RESPONSE TO REQUEST FOR ADDITIONAL INFORMATION

APR1400 Design Certification

Docket No. 52-046

RAI No.: 255-8285
SRP Section: 03.08.05 - Foundations
Application Section: 03.08.05
Date of RAI Issue: 10/19/2015

Figure1 Node Locations at EDG Basemat for checking settlements (Static)

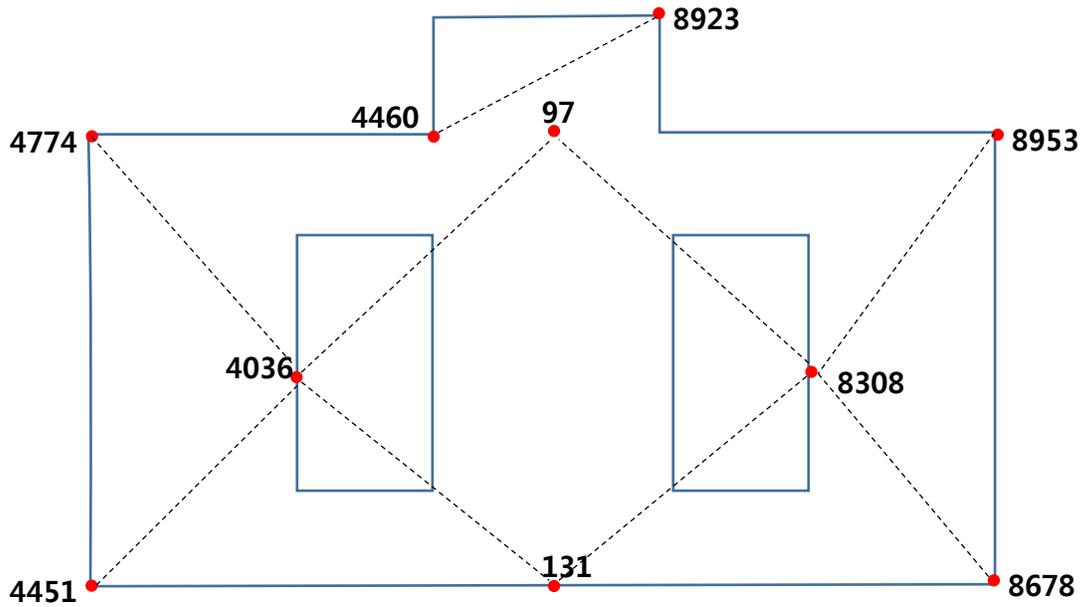
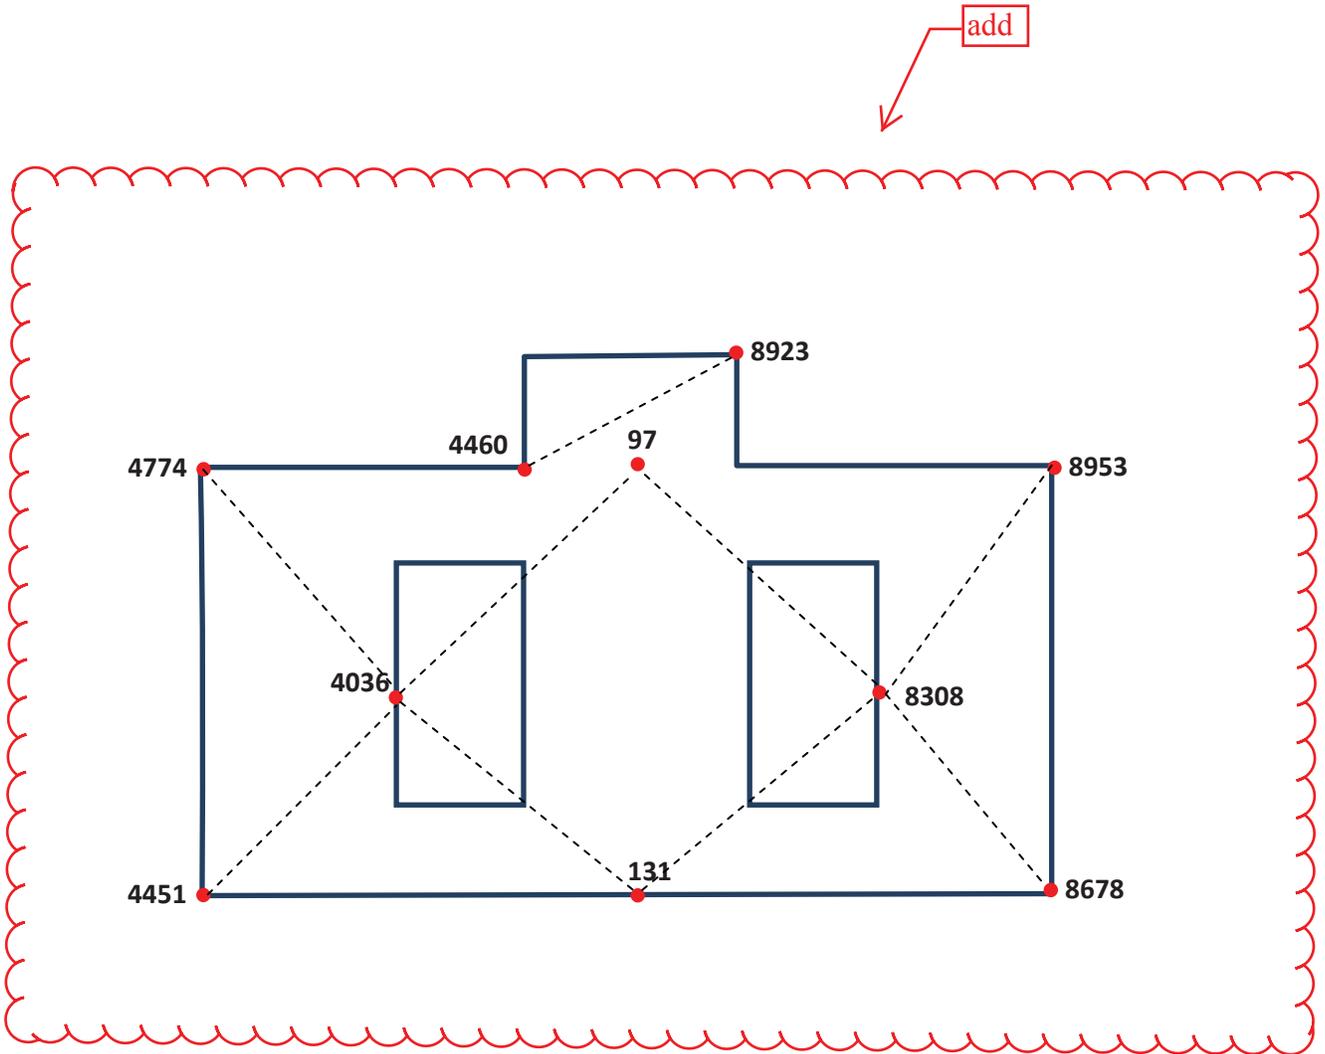
In DCD Tier 2, Appendix 3.8A, "Structural Design Summary," subsection 3.8A.3.4.1, "Basemat," the applicant describes the settlement analysis performed for the EDG & DFOT basemats and refers to Table 3.8A-39, "EDG & DFOT Buildings Differential Settlement According to Site Profile (static)," for the differential settlements calculated at different nodes of the EDG and DFOT buildings. However, the locations of the nodes were not provided in a similar fashion as they were for the NI basemat (as in Figures 3.8A-18 and -19). Therefore, the applicant is requested to provide the locations of nodes at the EDG & DFOT basemats for checking settlements, and include this information in DCD Appendix 3.8A.

For the differential settlements of the EDG & DFOT basemat, the static load (dead and live load) is applied. The location of nodes used to check the settlements are spaced approximately 50 ft apart. Figures 1 and 2, below, show descriptions and node locations at the bottom of the EDG & DFOT basemat. In addition, these figures will be added to DCD Appendix 3.8A as shown in the attachment to this response. The differential settlement for the EDG & DFOT is summarized in DCD Tier 2, Table 3.8A-39.

Figure 3.8A-57 and Figure 3.8A-58 show the node locations at the bottom of the EDG & DFOT basemat for checking the settlements. The analysis of multiple of settlements (long and short term) will use these nodes.

Figure 1 Jurisdictional Boundary for Design of Common Basemat

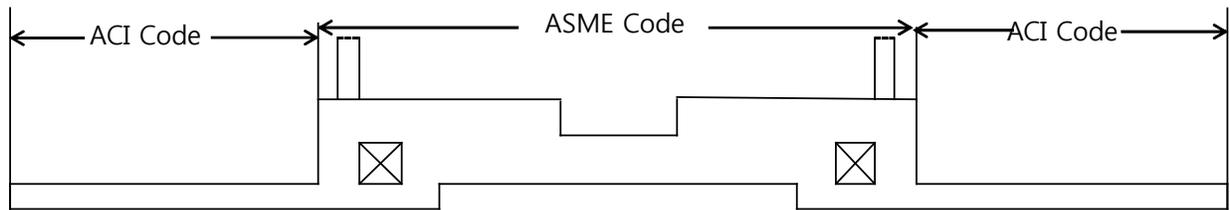
10 CFR 50.55a and Appendix A to 10 CFR Part 50, General Design Criteria 1, 2, 4, 16 and 50, provide the regulatory requirements for the design of the containment internal structures. Standard Review Plan (SRP) 3.8.5, Section II specifies analysis and design procedures applicable to the foundation of seismic Category I structures.

Load combinations and load factors for the RCB and the AB basemats are selected based on their relevant design codes, ASME and ACI respectively. The boundary of code jurisdiction between the ASME code and the ACI code is shown in Figure 1. The details of the code jurisdiction boundary are presented in the response to RAI 199-8223, Question 03.08.01-11.

For the RCB basemat, the 5 loading combinations (test, normal, severe, abnormal, and abnormal/extreme environmental) are selected as the critical loading combinations in the analysis of the NI basemat. Table 1 shows the selected load combinations and applicable load factors for analysis.
